## DEVIATION REQUEST AND DECISION FORM

Project Name : Skyline at Lorson Ranch  
Schedule No.(s) : 5500000440, 5500000274, 5500000275, 5513300005, 5513310105  
Legal Description : See Attached

A deviation from the standards of or in Section 2.2.5 (E) of the Engineering Criteria Manual (ECM) is requested.

**DEVIATION 1  
EXHIBIT**  
12/20/2021

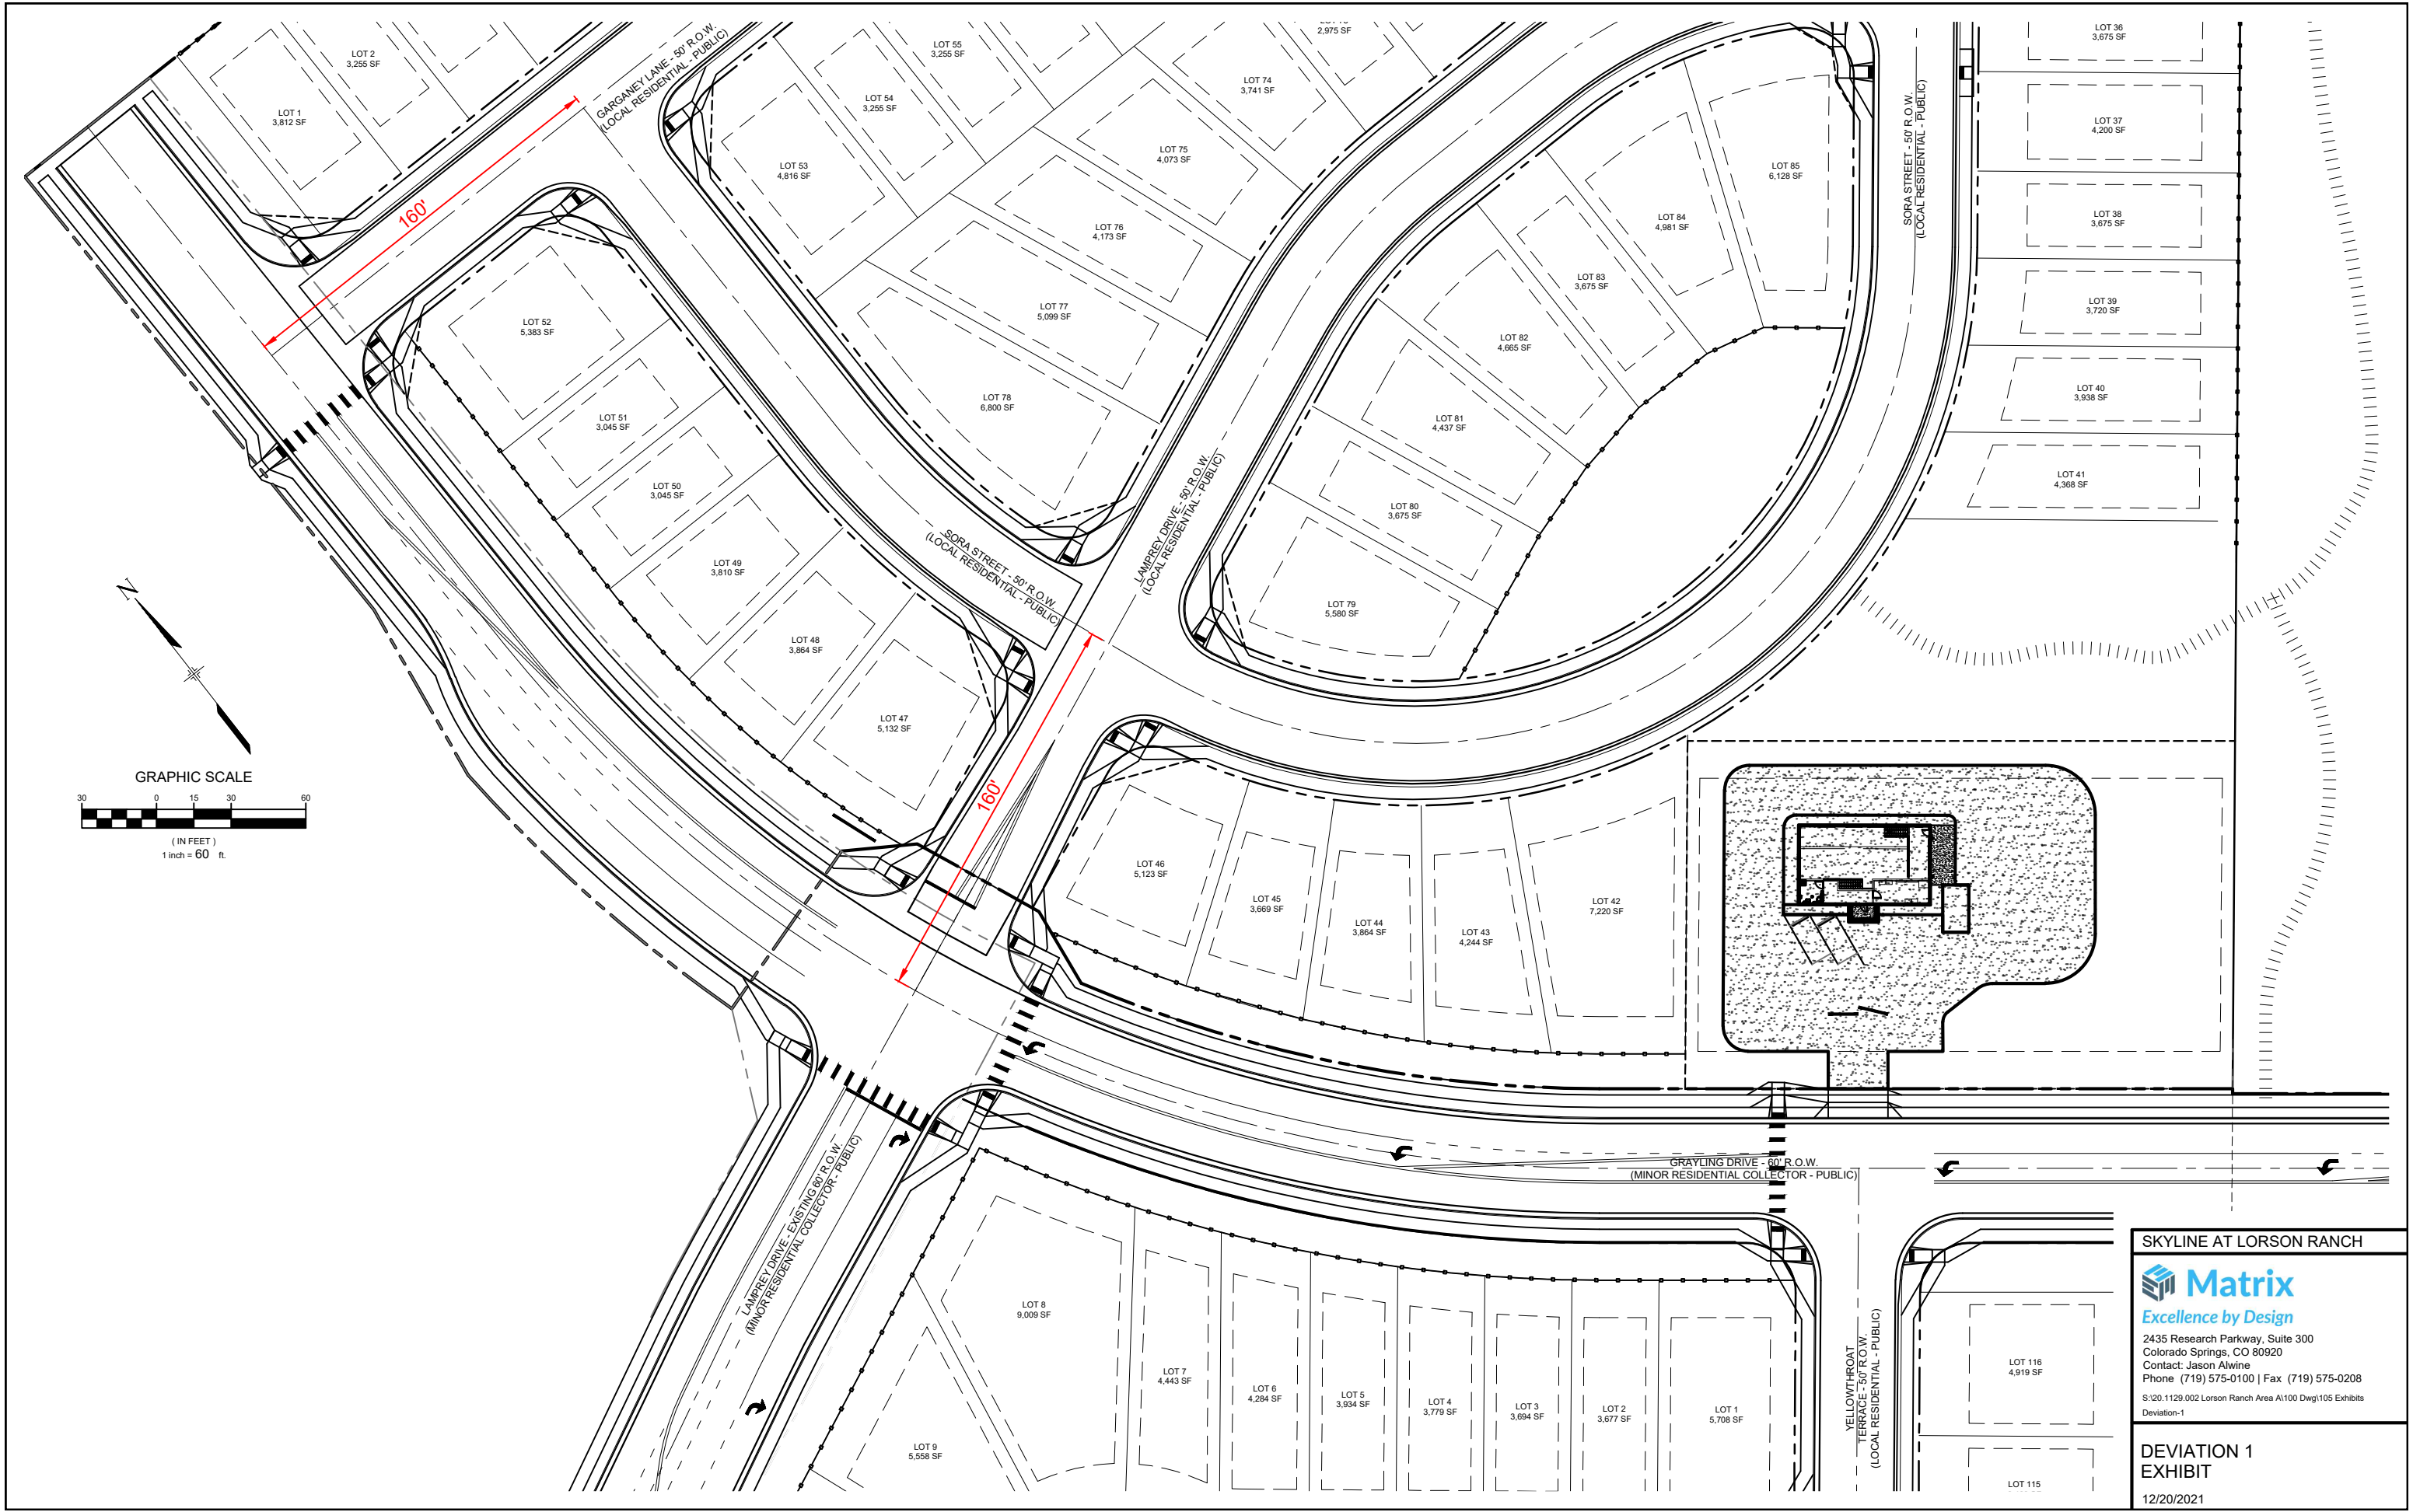
This should be 200' for spacing from collectors. Describe what the other design options would be and why they wouldn't work (longer lots or a tract behind the lots).

Maybe address the anticipated future function of Grayling (level of traffic and speeds, etc.)

Address sight and stopping distances with the reduced lengths, and conflicting traffic movements (driveways)

Will this add more road surfaces proportionally compared if the spacing was met? or can the same number of roads (or lane miles) be constructed if spacing was per criteria? for example, if you consistently do this over a large area, you could have more lane miles, thus adding to the cost of maintenance. Please add additional support to this section.

Just stating that it doesn't is not adequate. Please elaborate. For example, 160' vs 175' would look the same to a person at the intersection, there are not added roads or multiple of these shortened intersections in a row to appear as if there is an excess of intersections.
